HISTORIC AND DESIGN REVIEW COMMISSION

August 07, 2019

HDRC CASE NO: 2019-400
ADDRESS: 930 HAYS ST
LEGAL DESCRIPTION: NCB 1657 BLK E LOT N 141 FT OF 8 & N 141 FT OF E 16.2 FT OF 7
ZONING: RM-6, H
CITY COUNCIL DIST.: 2
DISTRICT: Dignowity Hill Historic District
APPLICANT: Chris Coker/BLUE LINE HOUSING LLC
OWNER: Chris Coker/BLUE LINE HOUSING LLC
TYPE OF WORK: Fenestration changes; door replacement
APPLICATION RECEIVED: July 16, 2019
60-DAY REVIEW: September 14, 2019
CASE MANAGER: Edward Hall
REQUEST:

The applicant is requesting a Certificate of Appropriateness for approval to perform various exterior modifications to the historic structure at 930 Hays. Within this request, the applicant has proposed the following:

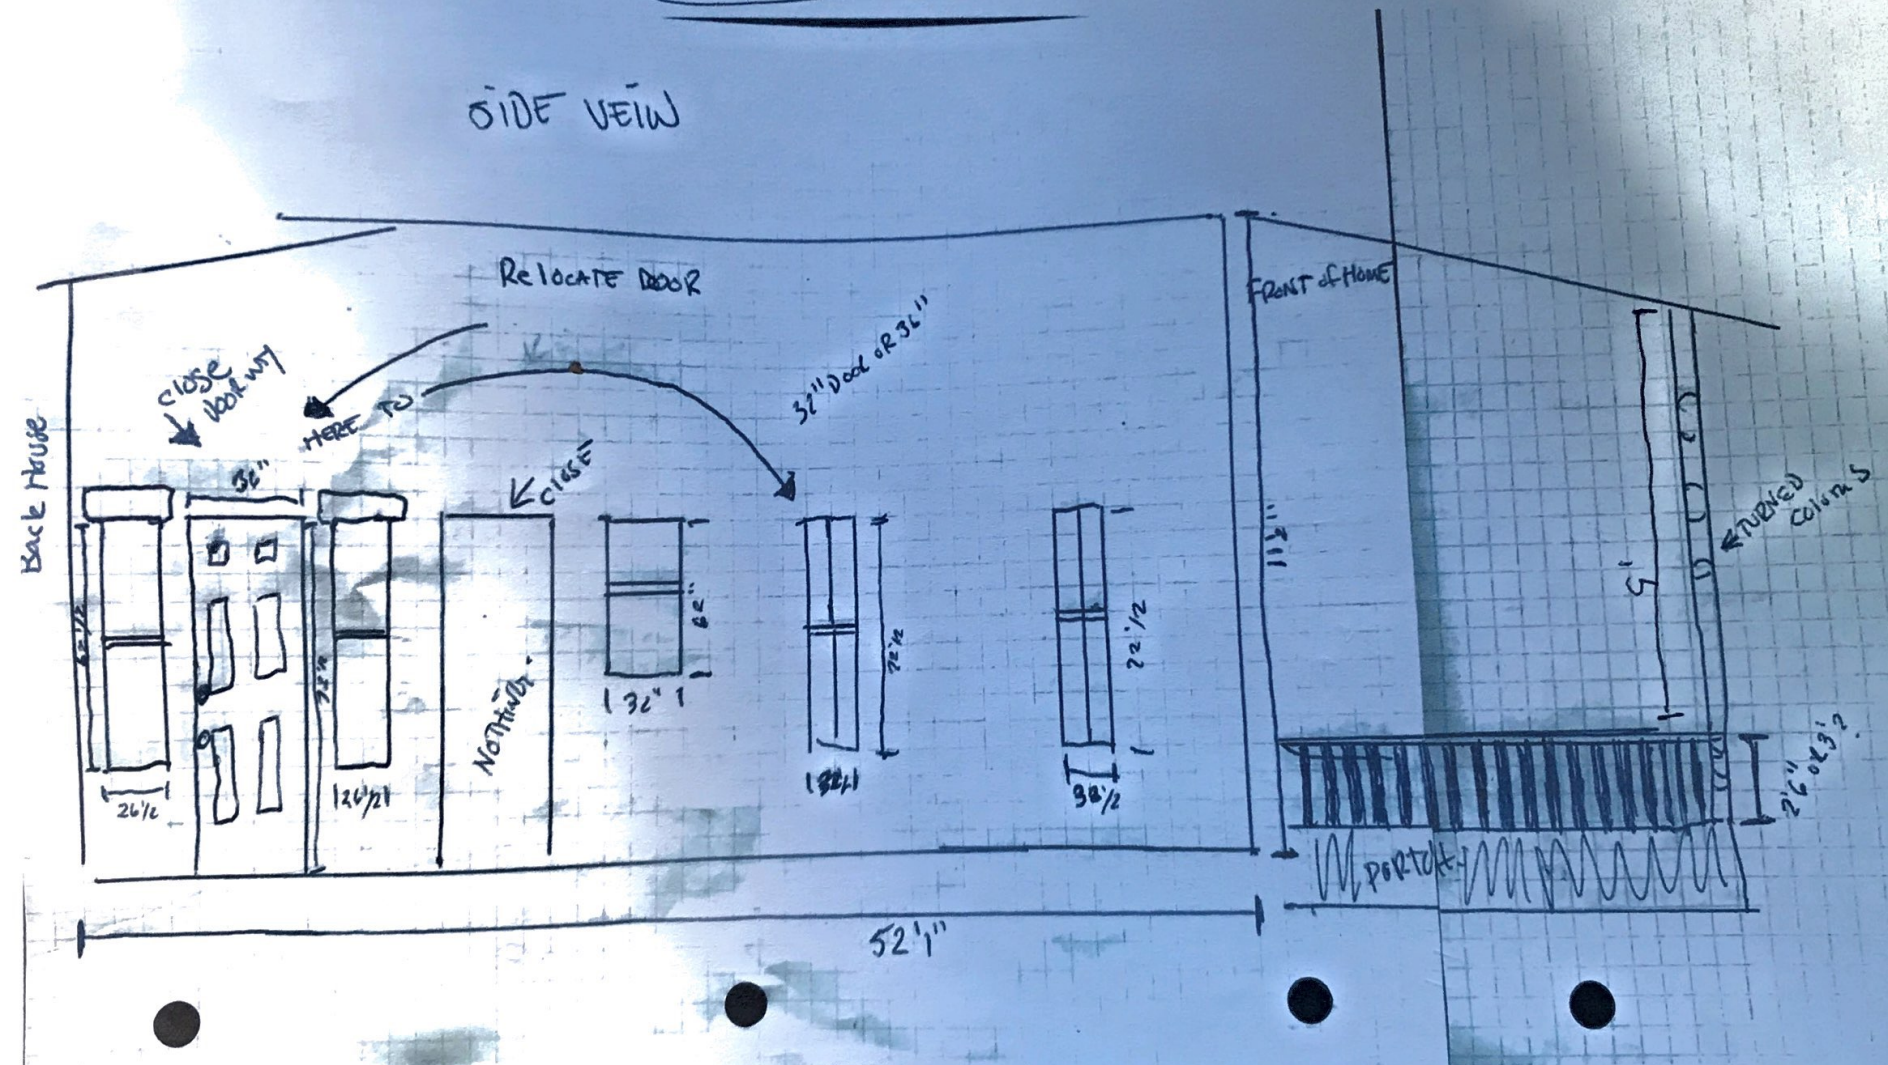
- b. FENESTRATION MODIFICATIONS – The applicant has proposed to modify the east elevation by enclosing an existing, non-original door in the rear addition, and modify an original window opening into a door opening. The Guidelines for Exterior Maintenance and Alterations 6.A.i. notes that existing window and door openings should be preserved. Additionally, the Guidelines note that new window and door openings should not be created on a primary façade, or where visible from the public right of way. While not original to the structure, the rear addition is found on the 1951 Sanborn Map. Staff finds that existing window and door openings should remain as they currently exist, to be consistent with the Guidelines. Existing door openings may be covered from the interior through the construction of a furr wall.

Staff does not recommend approval of item #1, fenestration modifications to the east façade based on finding b. Staff recommends that at least one door opening remain as it currently exists.
